PRELIMINARY FLOOR PLAN  
OFFICE CONTROL ROOM  
MOC-01

ELEVATIONS & DRAWING LIST  
OFFICE CONTROL ROOM  
MOC-01

PROJECT NAME: Murphy Oil Cadotte 1780-025

DOCUMENT DESCRIPTION: Millwork #2 Office Control Room  
MOC-01

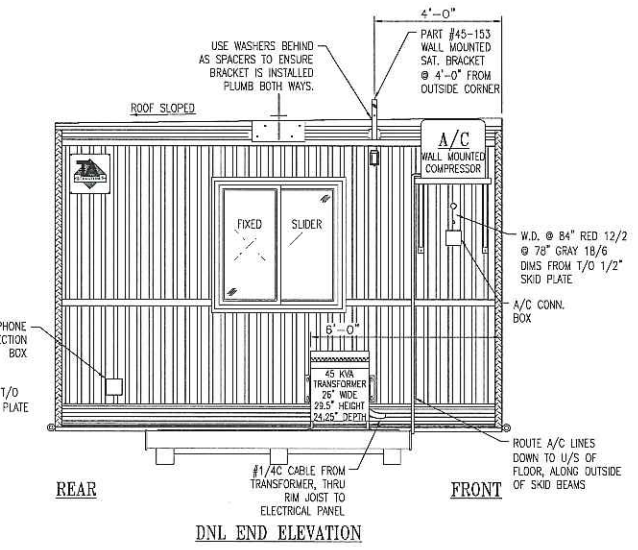
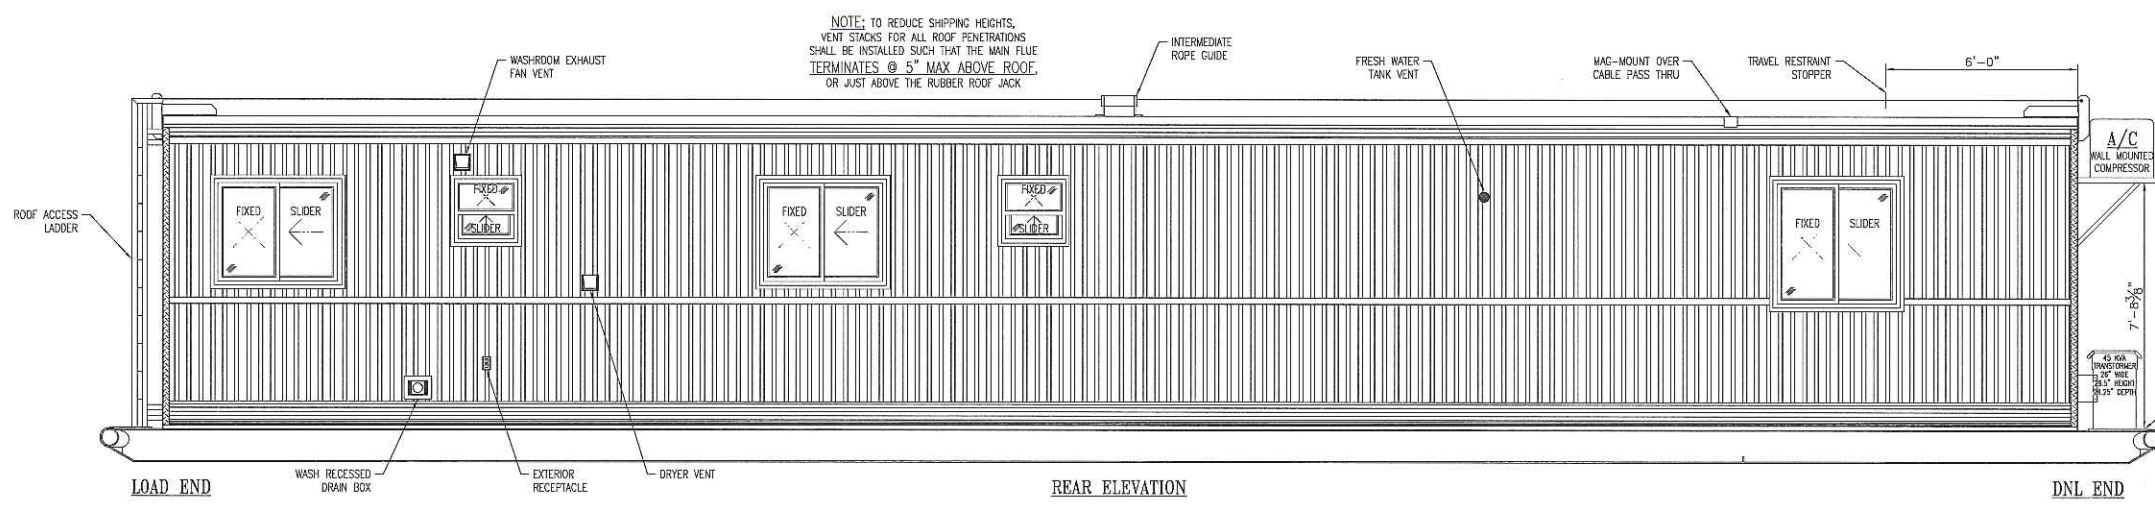
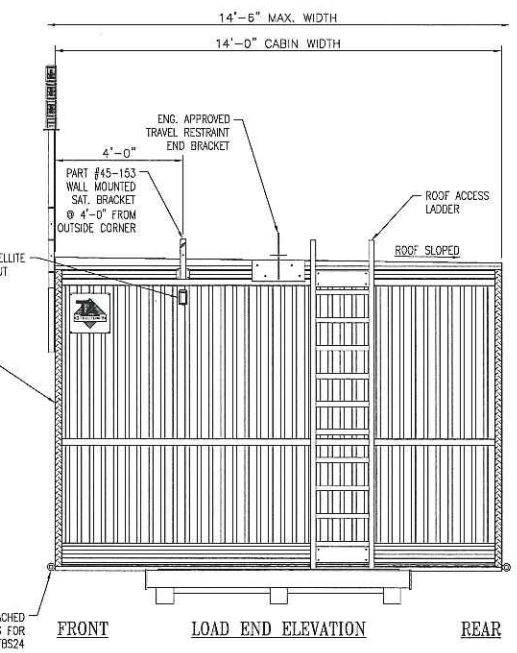
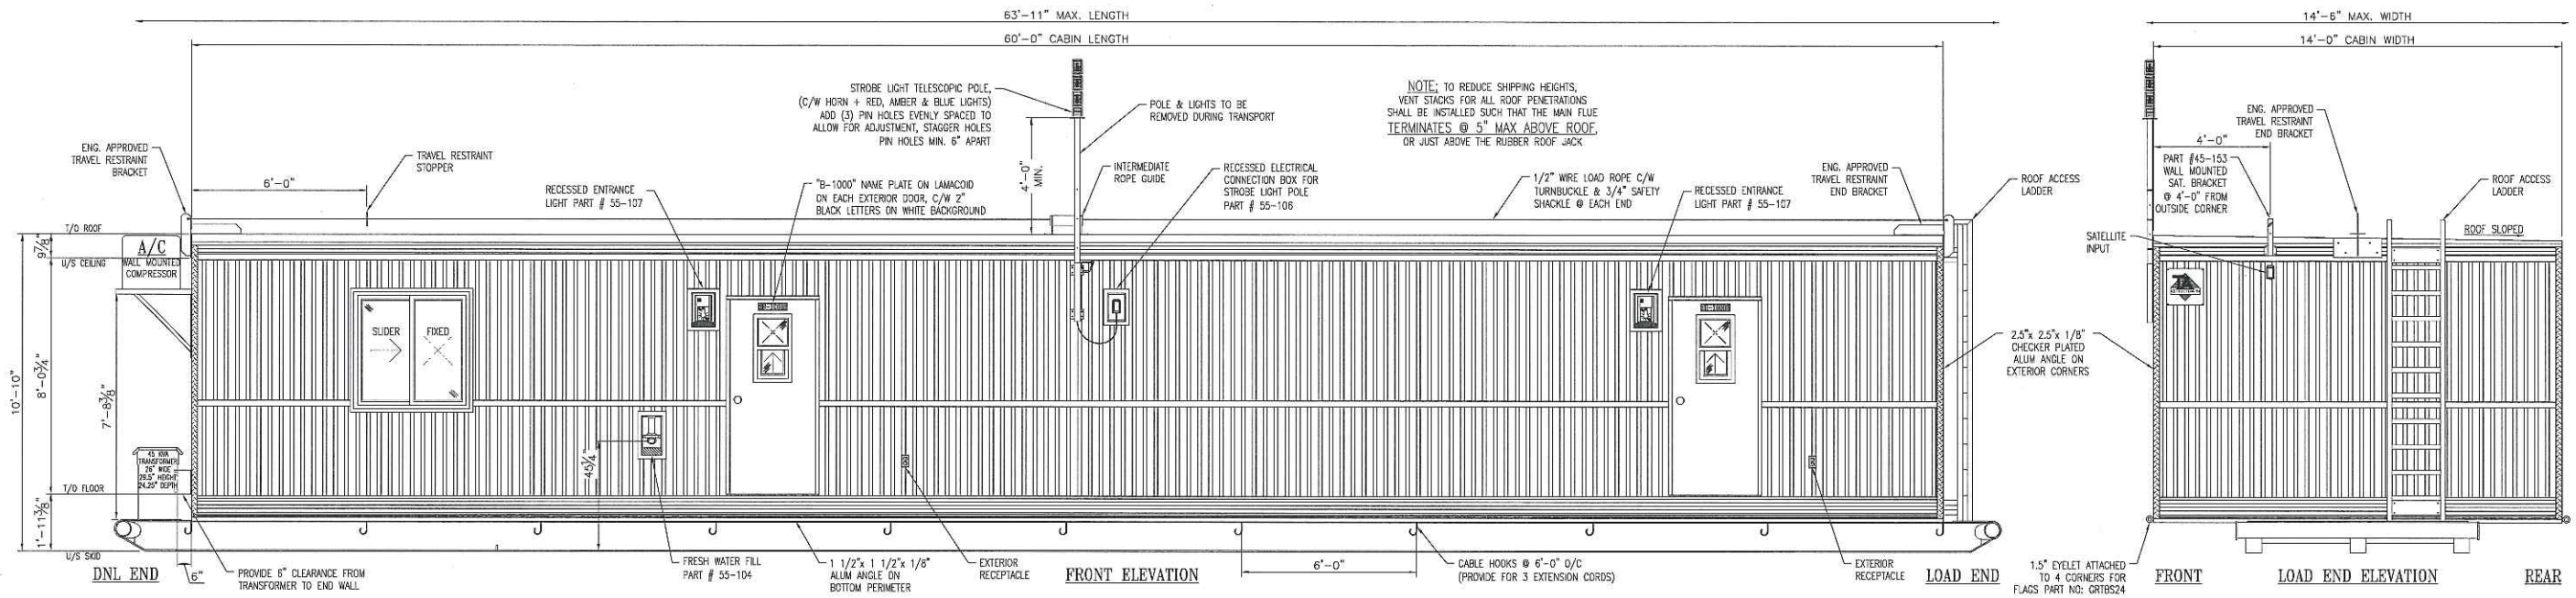
REV#	DESCRIPTION	DATE
REV A	ADDED SINGLE BOWL SINK, MOVED STROBE LIGHT POLE, ADDED TRANSFORMER	MAR. 21/12

SKID WITH PILE LAYOUT  
 OFFICE CONTROL ROOM  
 MOC-01

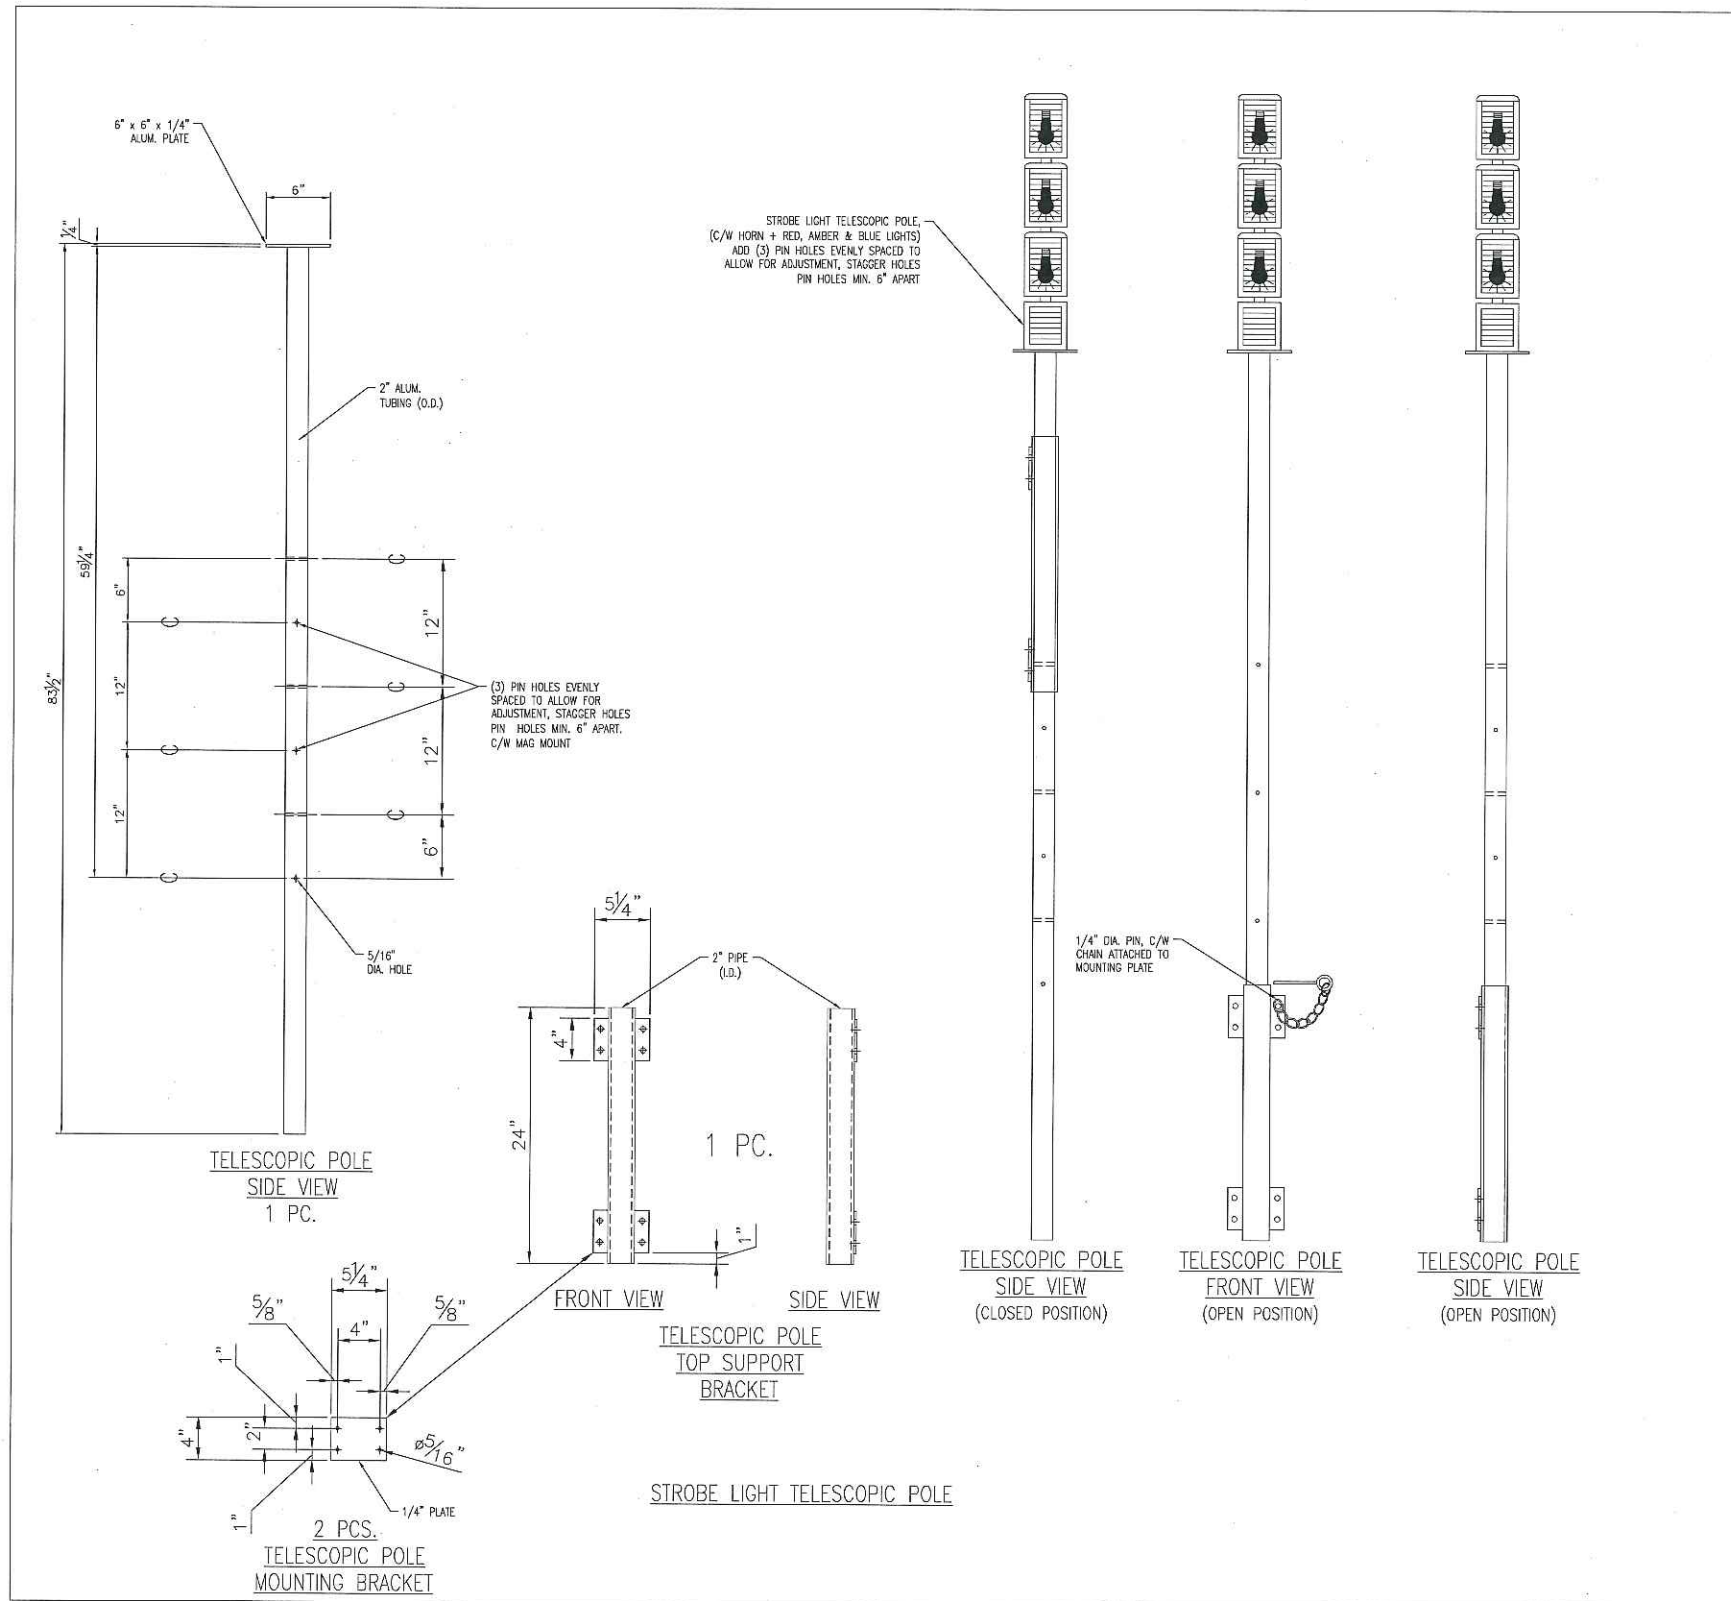
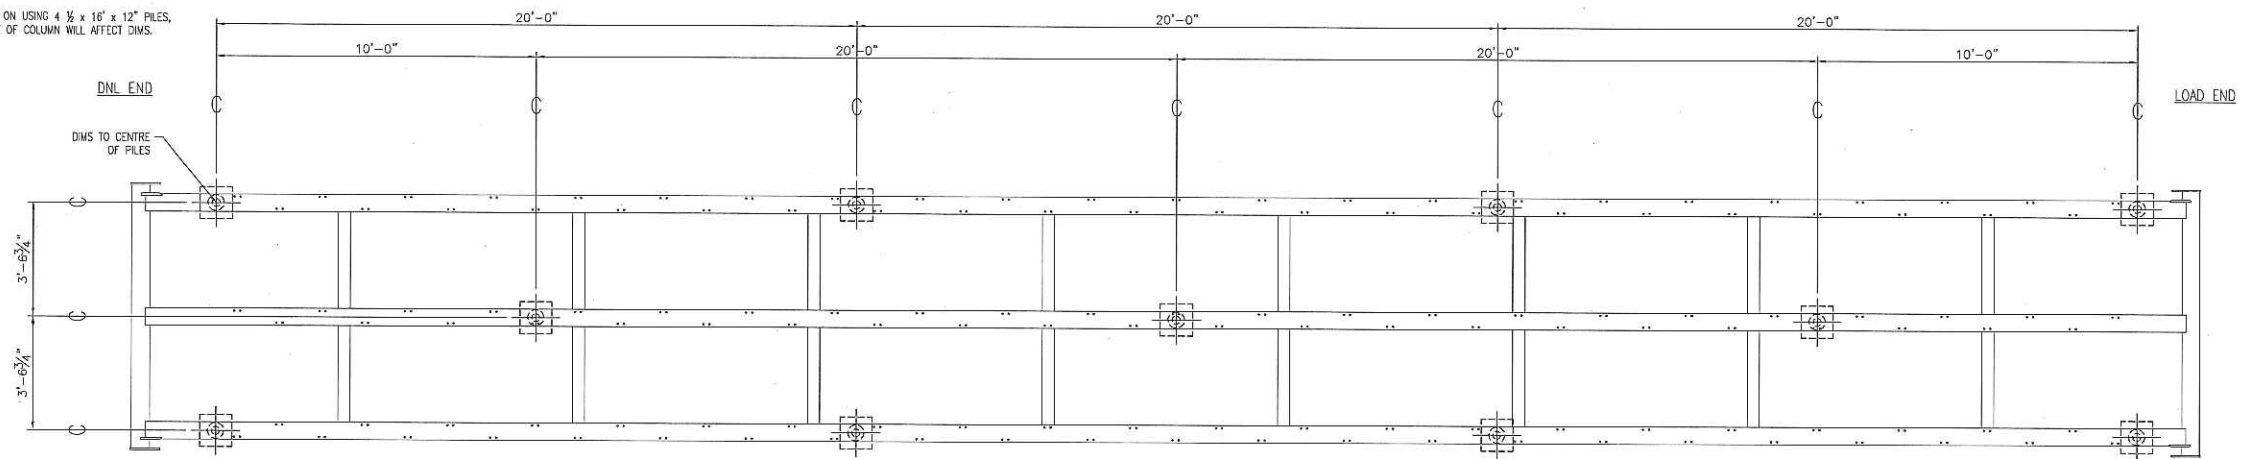
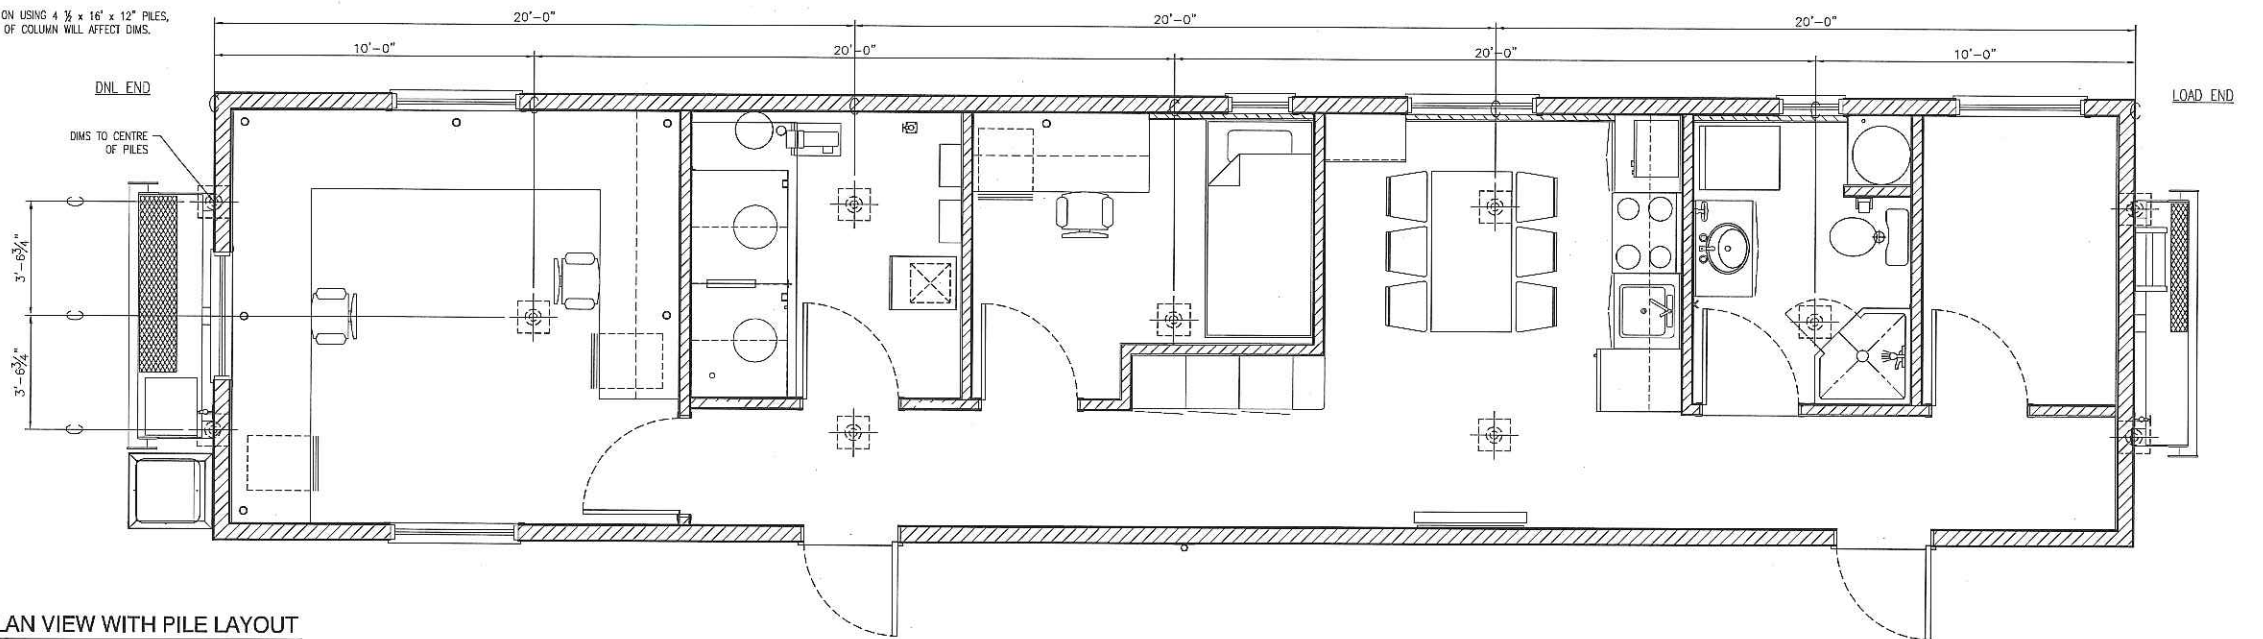
REV#	DESCRIPTION	DATE
REV A	ADDED CENTRE ROW OF PILES	APR. 20/12
